Comments on the planning proposal for the UK Holocaust Memorial and Learning Centre

Victoria Tower Gardens, Westminster

Jeremy Barrell BSc FArborA DipArb CBiol FICFor FRICS

Figure 2: Plane roots uncovered during excavations outside the Connaught Hotel, Mayfair, in 2011, showing roots (yellow arrows) of 20–30cm and greater diameters, at depths of up to 4–5m below ground level.

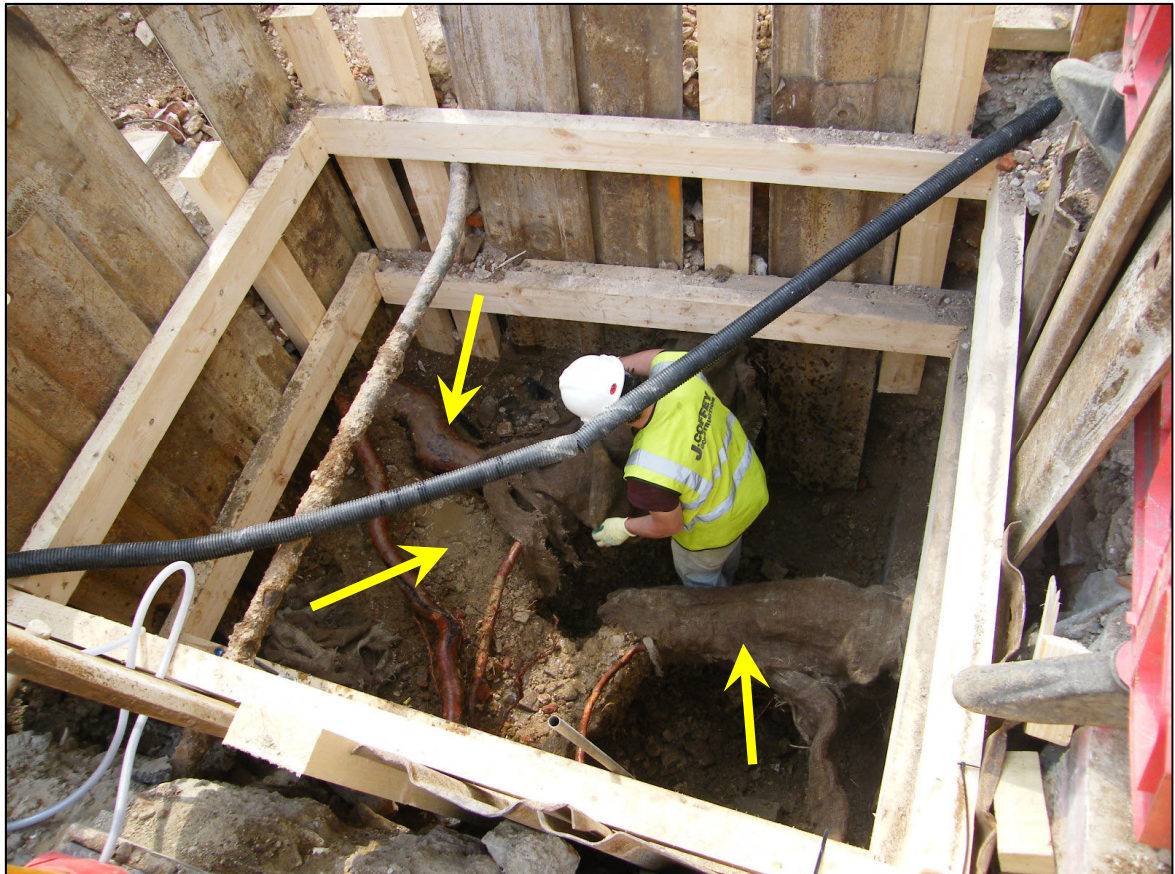
My experience working in the subsidence and planning sectors in London, backed up by photographic and documentary evidence, is that plane can and often do root down to depths of 4–6m, and sometimes deeper, especially in places where there are soil voids created from backfilling. For example, in 2011, I oversaw excavations in the public realm outside the Connaught Hotel in Carlos Place, Mayfair, related to the installation of a new

water feature that required deep excavations to install a storage water tank. During that project, very few roots were discovered in the top 1m or so of the soil profile because it was mainly concrete and other hard infrastructure. However, once the excavations progressed deeper, and some went down to 5m, extensive rooting was discovered in the deeper soil horizons. Indeed, Figure 2 shows an operative in one of the pits working around roots greater than 30cm in diameter at about 4m depth. These were plane trees significantly smaller than many of the trees in Victoria Tower Gardens.

In summary, my experience of multiple observations from subsidence investigations and development projects around London demonstrate that plane trees can and do regularly root to depths of 4–6m, and deeper. Furthermore, simple visual observations at the southern end of the Park confirm that a potential mechanism to supply fresh air and water to support deep rooting beneath the surface below 1m may exist, but has not been investigated in any detail or mentioned in the BC Report analysis.
